A Planning Application by
**CROUDACE HOMES, VORTAL HOMES LIMITED AND
FALCON DEVELOPMENTS (SE) LIMITED**

In respect of
**Land North of School Road, Arborfield Cross,
WOKINGHAM**

Designer's Response

Stage 1 Road Safety Audit

2.1 Problem

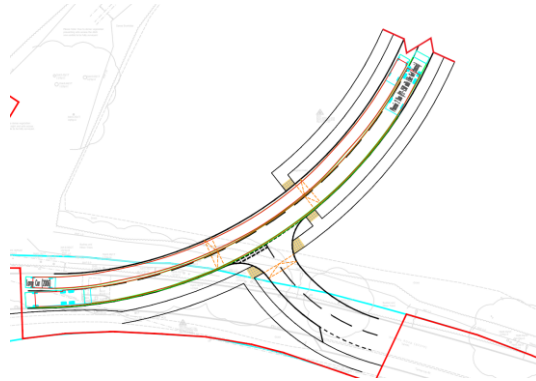
Location: Proposed crossing points

Summary: Proximity of proposed ramps could pose a risk to footway users

It appears from the drawing that the crossing points indicated above will be immediately adjacent to the raised table ramps. Particularly at busier times, and given that there is a school nearby, pedestrians could be at risk of losing their footing and falling if walking too close to the ramp.

It is recommended that the ramps are positioned a suitable distance from the crossing points, in order to provide a safe 'buffer' between the two.

- 2.2 Agreed, the proposed raised table ramps have been relocated circa 1m from the pedestrian crossing as shown in **Appendix B**.

PROPOSED SITE ACCESS ARRANGEMENT

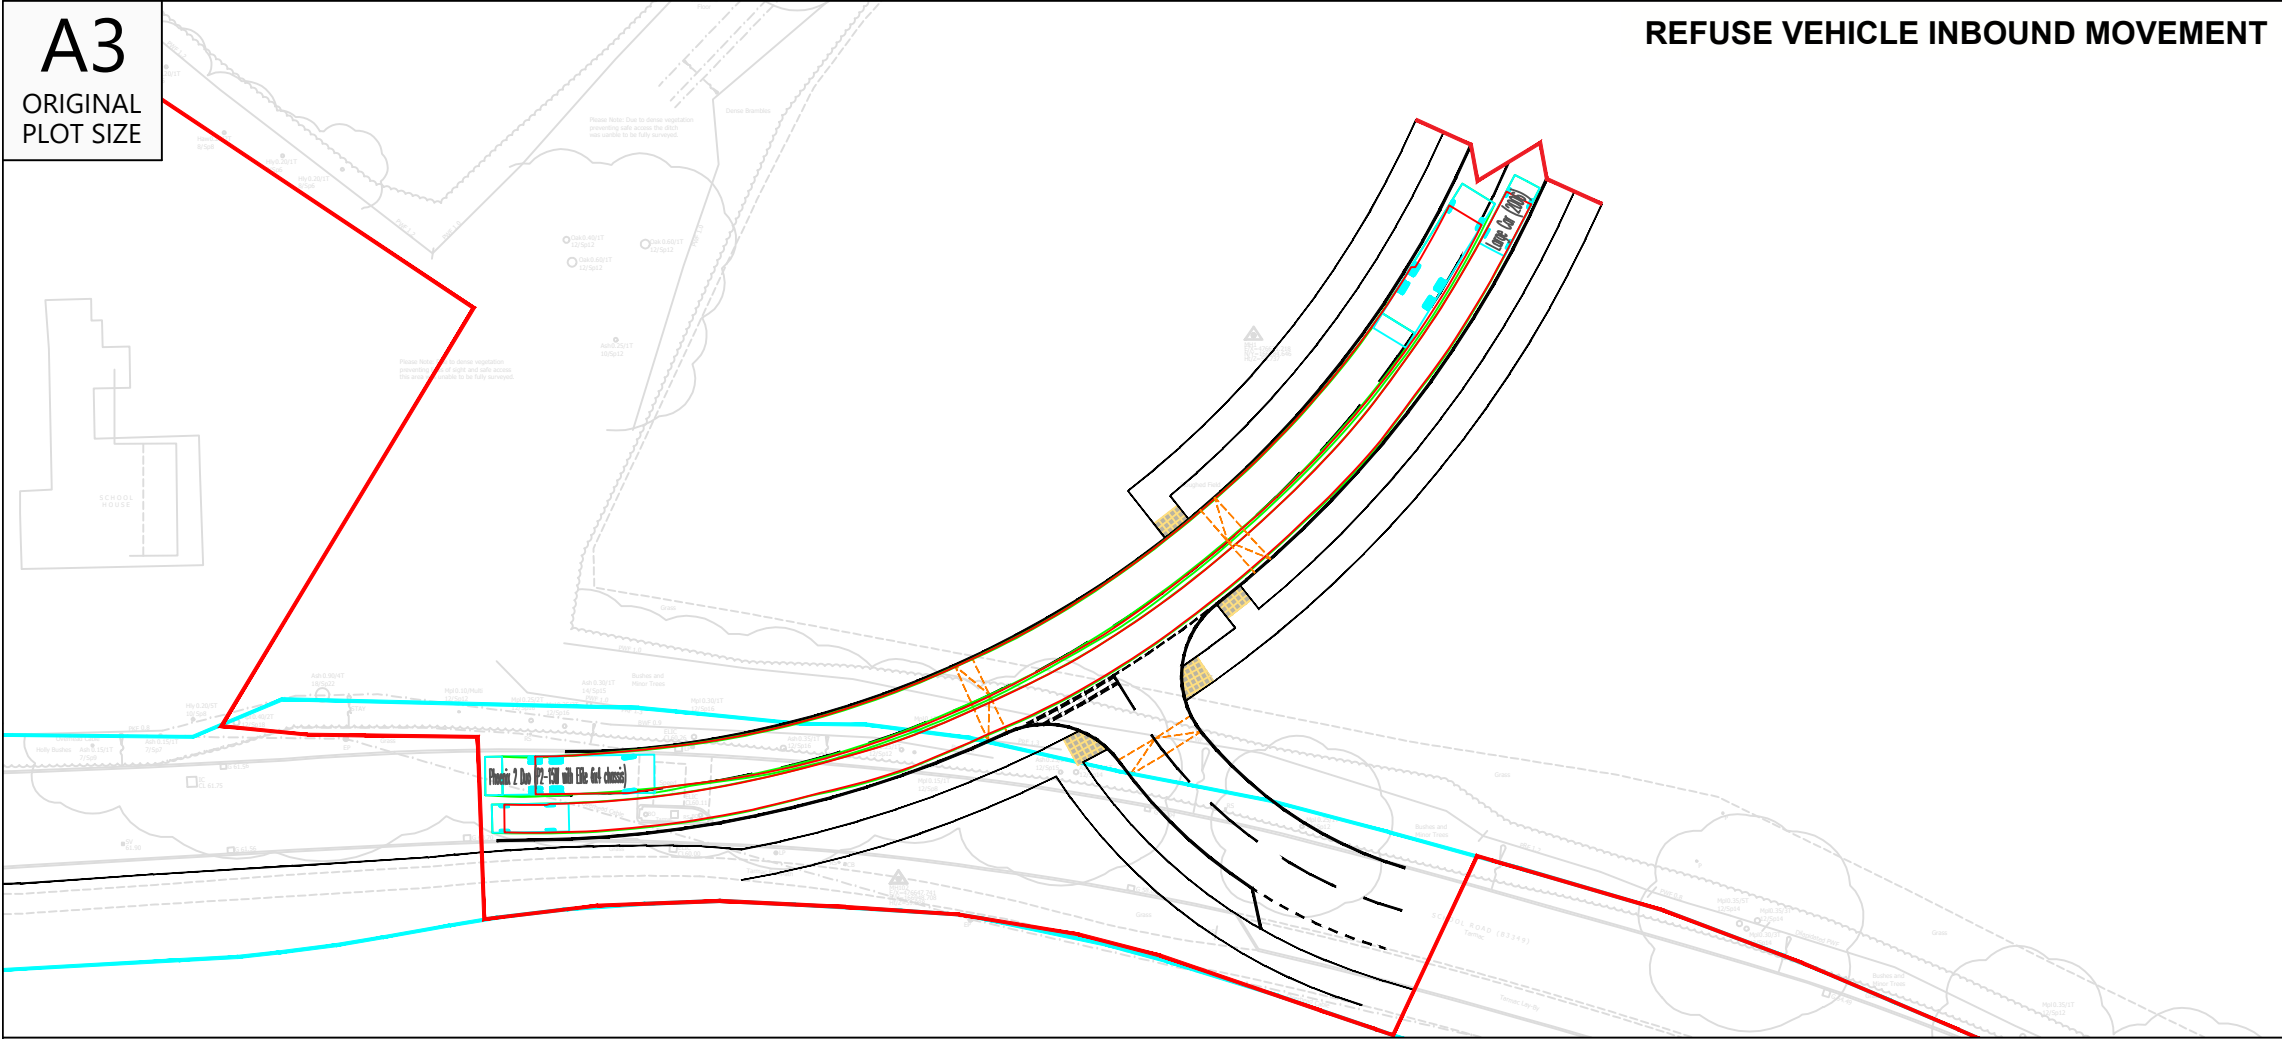
"It appears from the drawing that the crossing points indicated above will be immediately adjacent to the raised table ramps. Particularly at busier times, and given that there is a school nearby, pedestrians could be at risk of losing their footing and falling if walking too close to the ramp."

"It is recommended that the ramps are positioned a suitable distance from the crossing points, in order to provide a safe 'buffer' between the two."

TITLE:
SWEPT PATH ANALYSIS OF A
REFUSE VEHICLE PASSING A
LARGE CAR

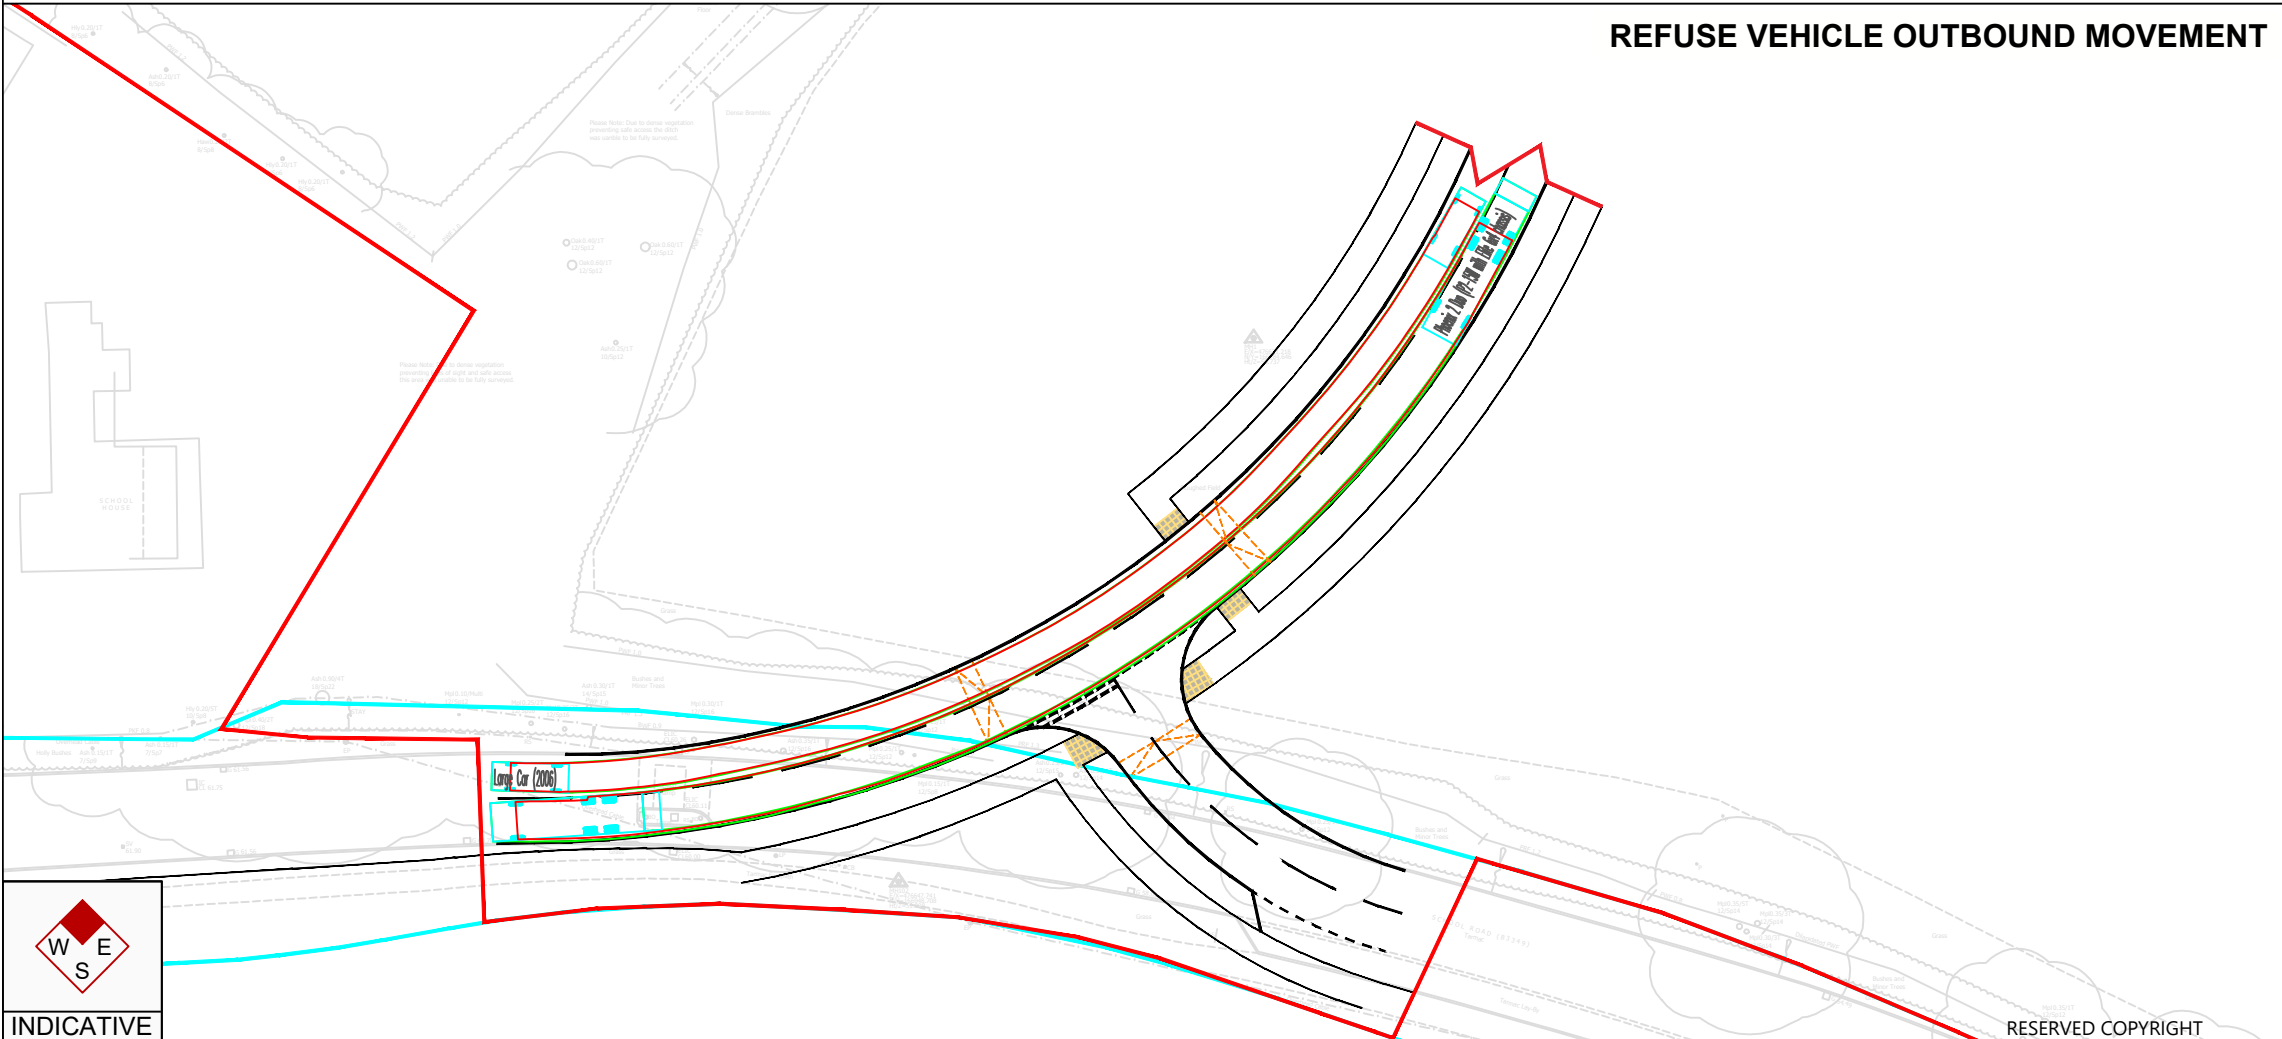
"The width of the existing parking bay is relatively narrow at 2m, and it is possible that some wider or poorly parked vehicles could protrude into the carriageway. Whilst this is an existing bay, the proposed carriageway realignment and nearby junction could increase the risk of conflict between parked and passing vehicles."

"It is recommended that scope for widening the parking bay is investigated. Also see Problem 2.2 with regard to the likely path of passing vehicles."

- 2.6 The proposals seek to provide a parking bay which conforms with the existing provision (2m width) and should be sufficient given that School Road a no-through road beyond the proposed junction and therefore a very low volume of movements is expected. Notwithstanding this, as shown in **Appendix B**, a large car can fit fully within the 2m wide parking space.

TITLE:
SWEPT PATH ANALYSIS OF A
REFUSE VEHICLE ON
SCHOOL ROAD

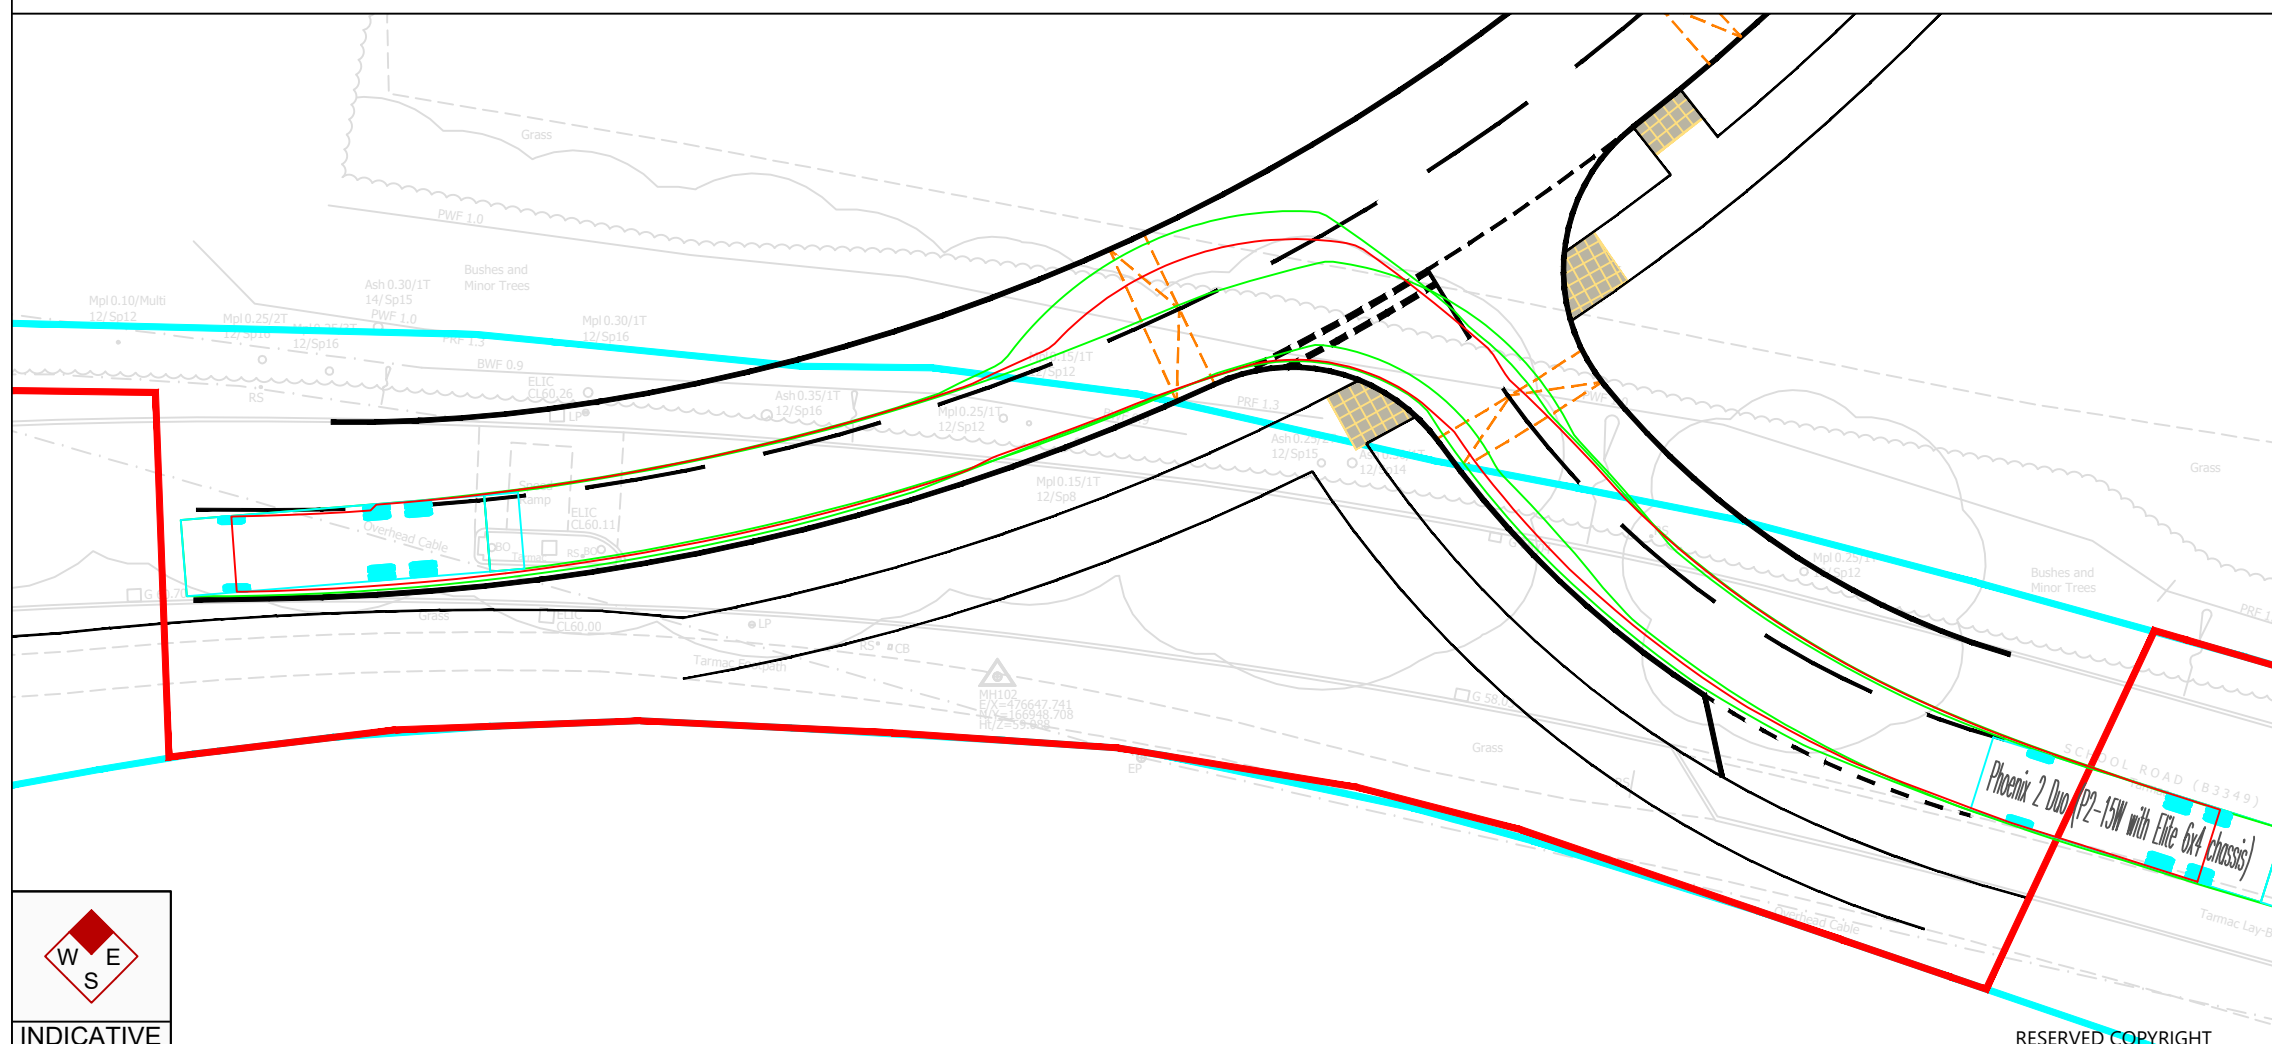
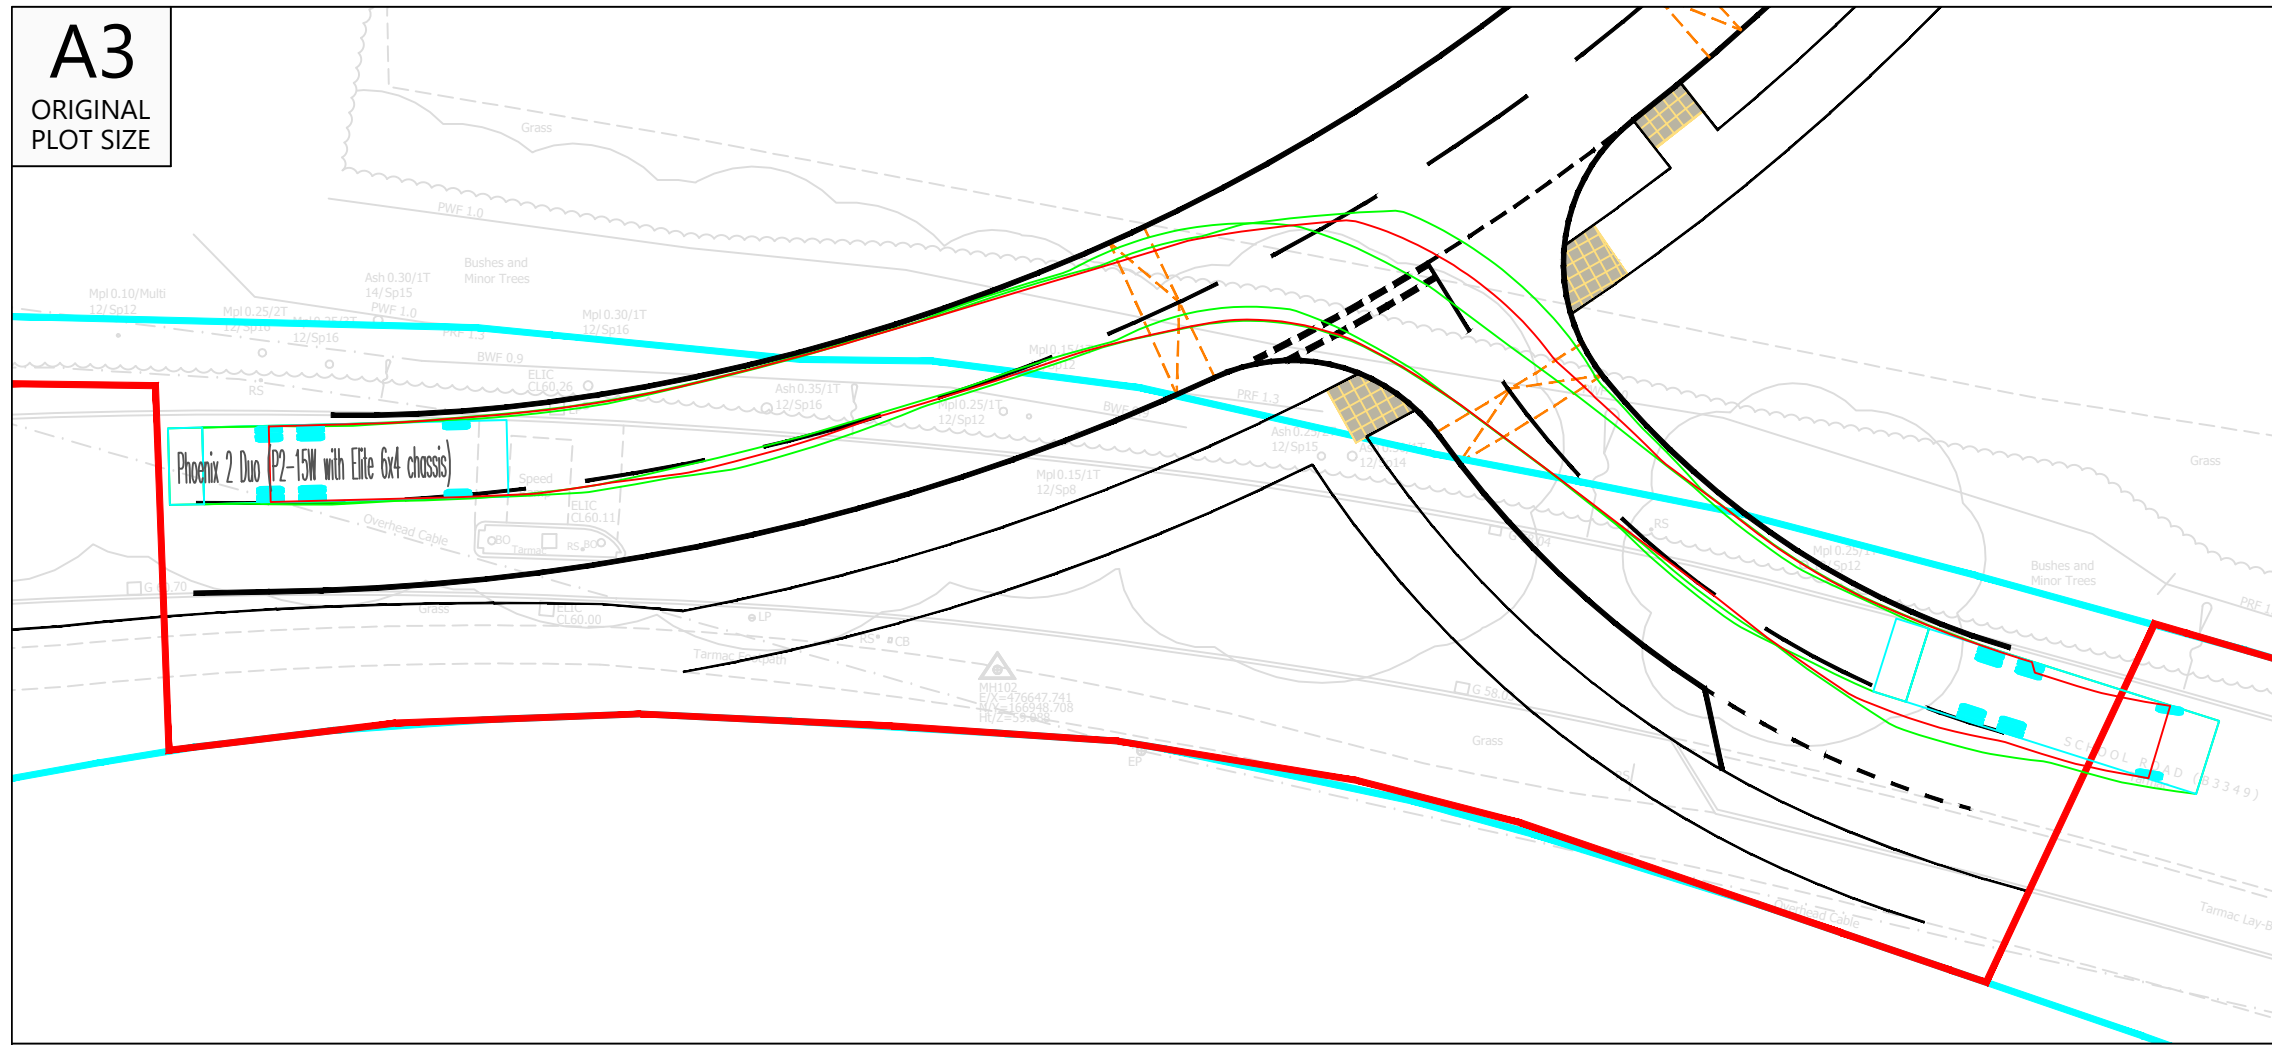
"Whilst a swept path analysis demonstrates that a larger refuse-type vehicle will be able to safely leave and enter the development site, this does not include any movements to/from the proposed priority junction. Although likely usage of the junction by larger vehicles is not known, there may be a risk to other road users, including pedestrians, if larger vehicles cannot safely negotiate the junction."

"It is recommended that further swept path analyses are undertaken in order to ensure that manoeuvres by the largest expected vehicle type can be safely accommodated within the proposed junction layout."

- 2.4 Whilst it is highly unlikely that a vehicle larger than a car would utilise the minor arm of the junction due to the existing bollards to the east on School Road and the limited turning space provided, swept path analysis has been undertaken for a refuse vehicle and is provided in **Appendix C**.
